MANDATORY SERVICE BULLETIN

MSB 42-138

MSB 42NG-080

Replacement of Fuel Tank Connection Hoses.

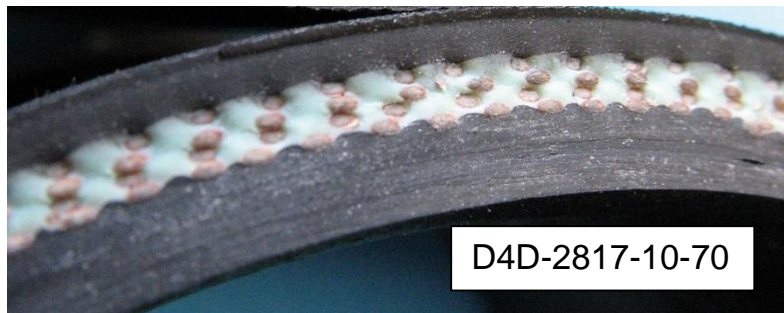
Note: The following pictures show the difference between the two types of fuel tank connection hoses in field.

- D4D-2817-10-70
 This fuel tank connection hose has a light blue layer in the cross-section.
 Only a fraction of these hoses come from the affected two batches.

- D4D-2817-10-70_01
 This fuel tank connection hose has an all black cross section and is not affected.

Quantity	Part Number	Description
4	D4D-2817-10-70_01	fuel tank connection hose
